The Corporation of the
Town of Milton
Committee of Adjustment and Consent

Thursday, August 27, 2026, 6:00 p.m.
Council Chambers - In Person

Report To: Committee of Adjustment and Consent

Subject: 1461 Leger Way

SITE PLAN

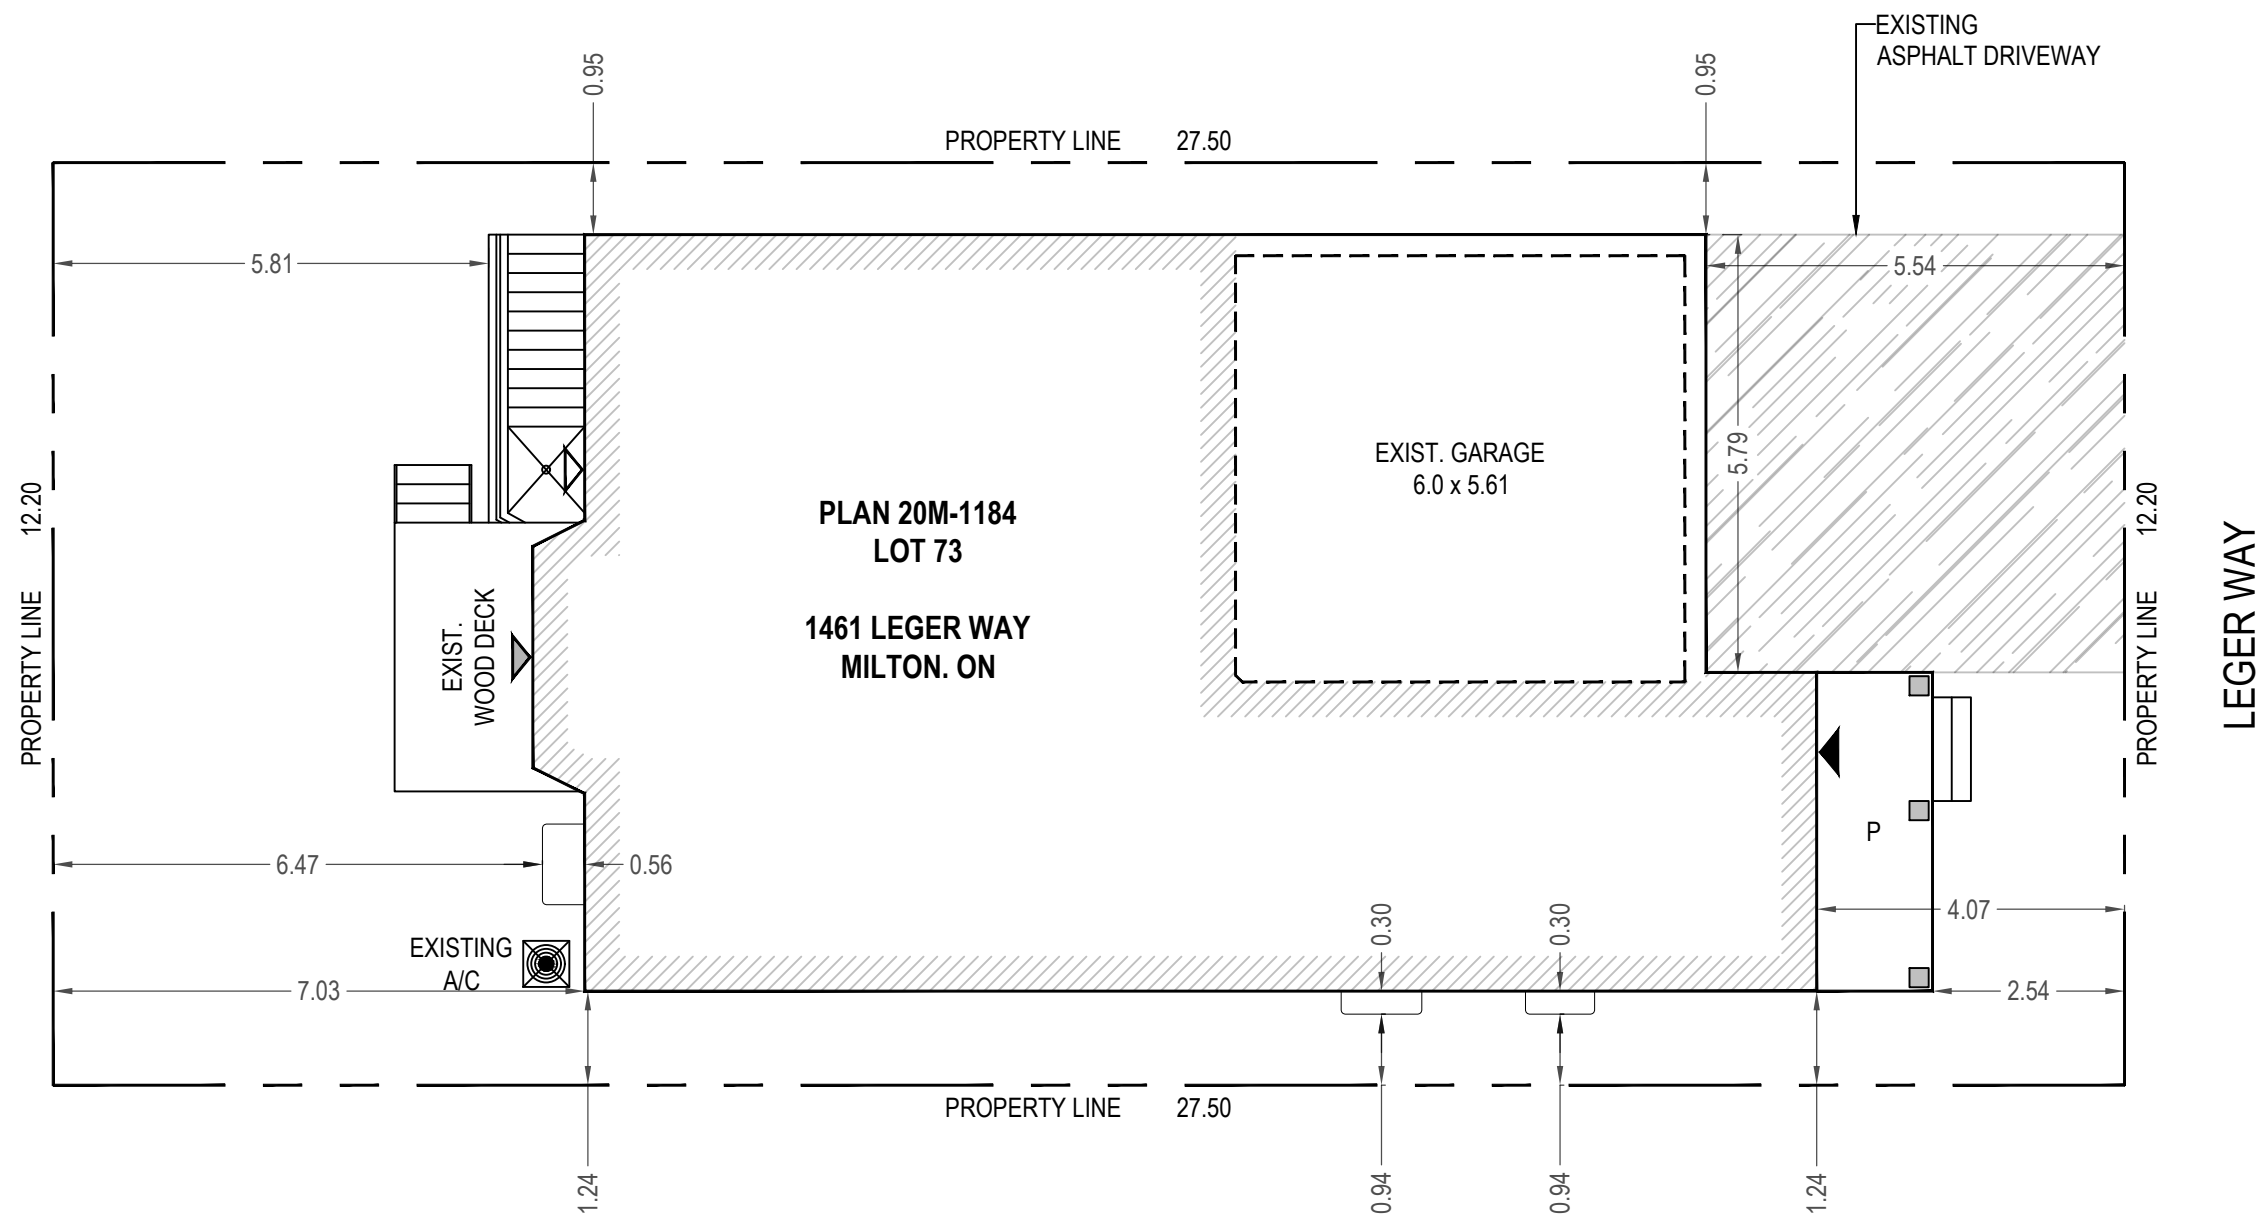
While the southern interior side yard, which provides the most direct route to the ARU entrance, has a width of 0.95 metres, Planning staff note that the northern interior side

The intent of this Zoning By-law provision is to ensure the access route leading to the entrance of an ARU is wide enough to remain safe and functional. In particular, the access route must be wide enough to ensure that emergency services personnel would be able to reach the ARU if needed. Planning staff are satisfied that the access route will remain safe and functional despite the proposed variance, maintaining the intent of the Zoning By-law. Additionally, the recommended conditions will require a sprinkler system to be installed within the ARU to mitigate any potential delays in Fire Department response time as a result of the variance.

4. THAT the full length of the northern interior side yard, having a width of 1.24 metres, shall remain and clear of any structures or obstructions for as long as the basement ARU remains in place;

DRAWING TITLE:
SITE PLAN

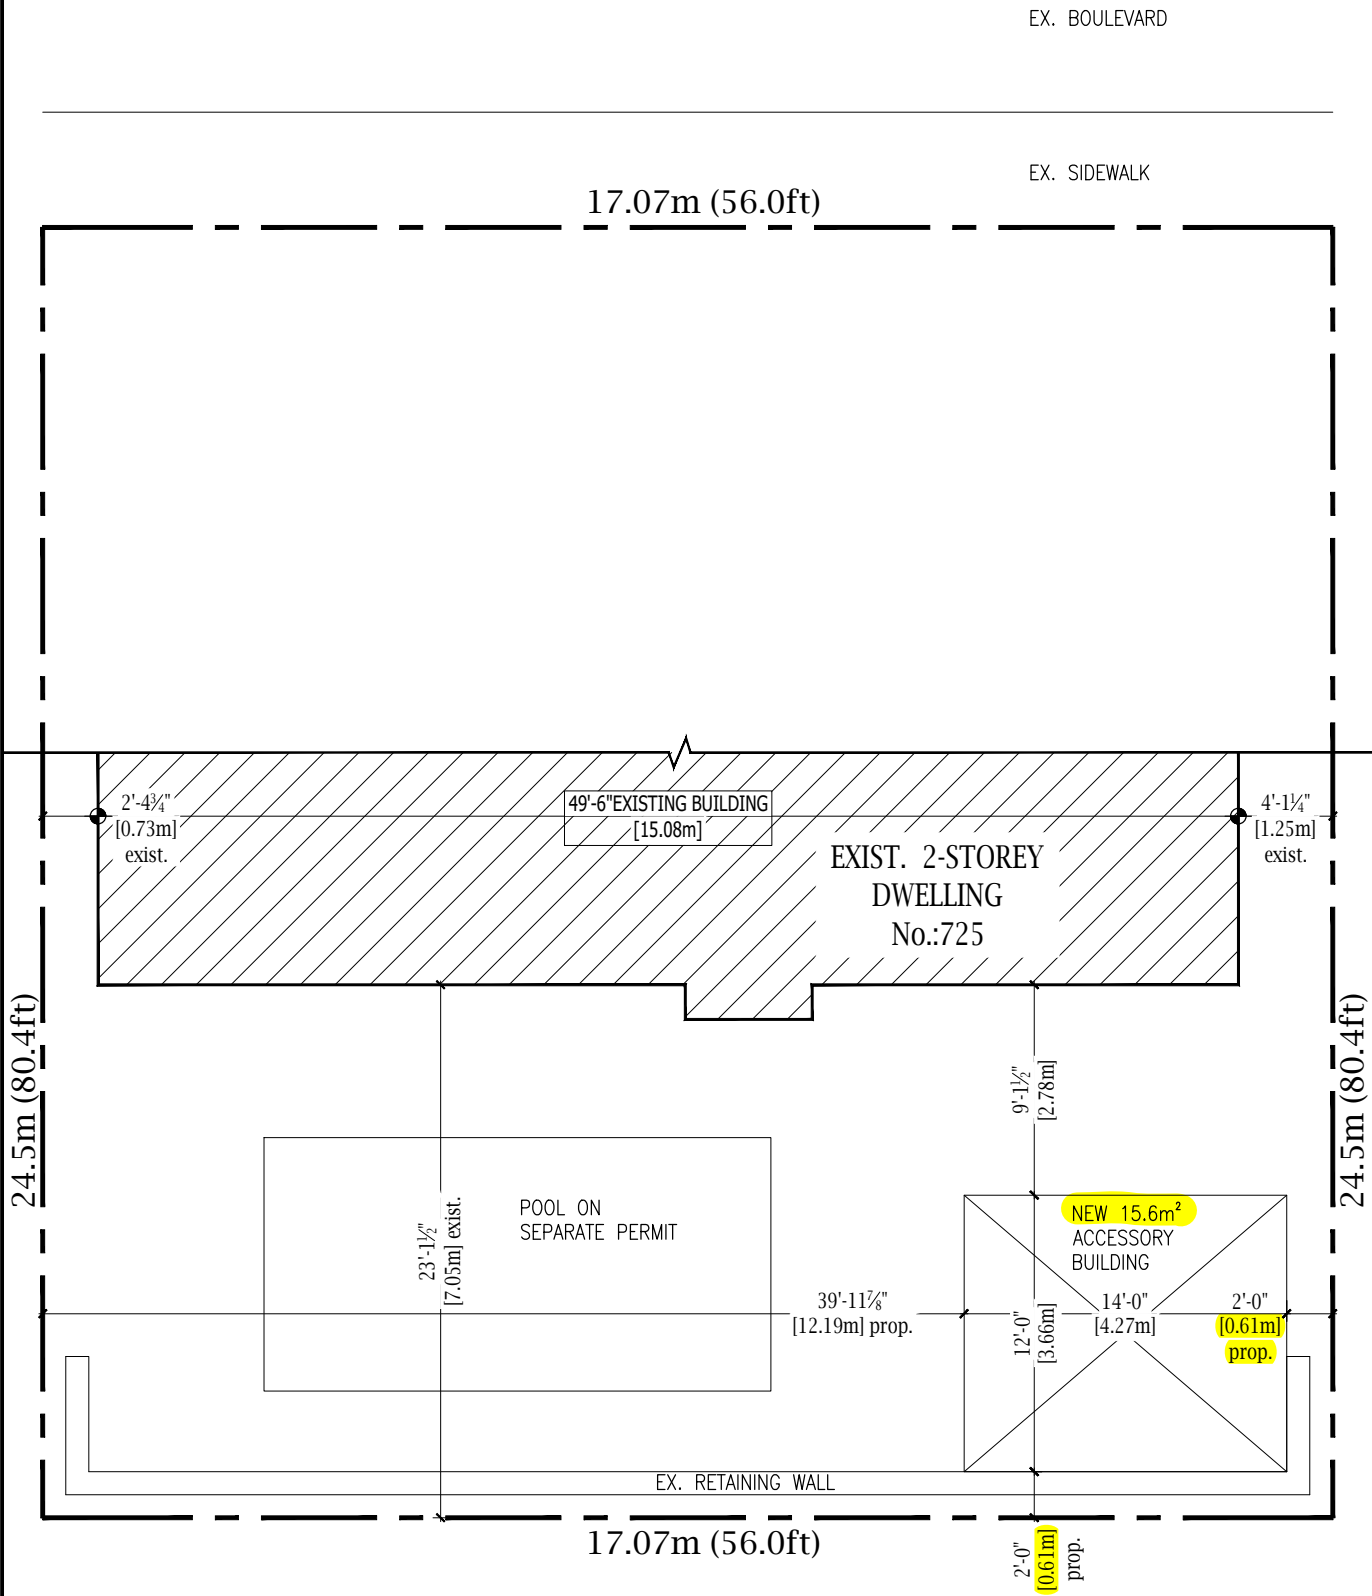
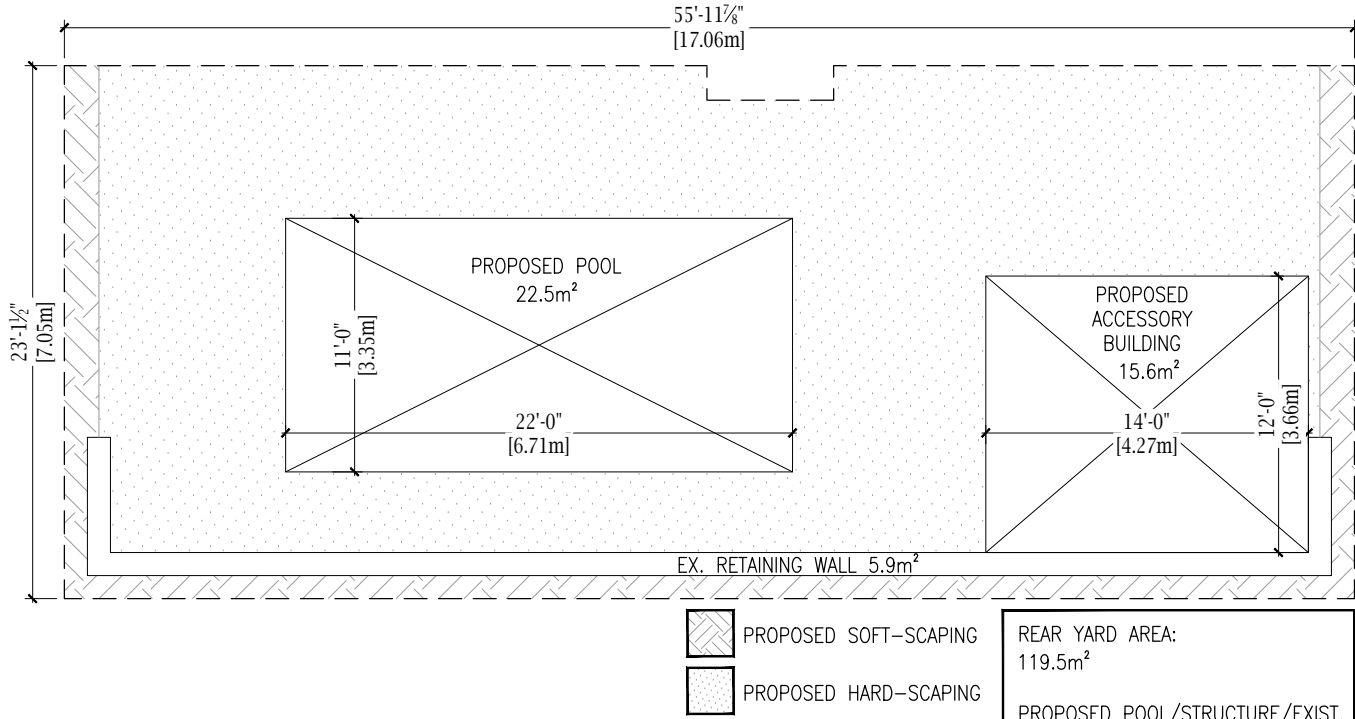
Town Development Engineering Staff reviewed the application and offer no objection, however, will require an updated Site Plan as part of the Building Permit process. This has been included above as a condition of development approval. The updated site plan will be required to include the following notes:

Planning staff do not have concerns with the requested variances for the proposed structure as it will meet the required side and rear yard setbacks from the property lines. Further, the structure meets the maximum height provisions and Town Engineering staff have confirmed from a drainage perspective there will be no negative impact to surrounding properties. It should also be noted it was confirmed there will be no changes or impacts to the existing retaining wall.

1. That the development shall be constructed in accordance with the site plan prepared by My House Designs & Drafting Services and stamped by Town Zoning on June 29, 2026.
2. That an updated Site Plan will need to be submitted during the Building Permit review process to the satisfaction of Town Engineering Staff;
3. That a Building Permit be obtained within two (2) years from the date of the decision; and
4. That the approval be subject to an expiry of two (2) years from the date of decision if the conditions are not met, if the proposed development does not proceed and/or a building permit is not secured.
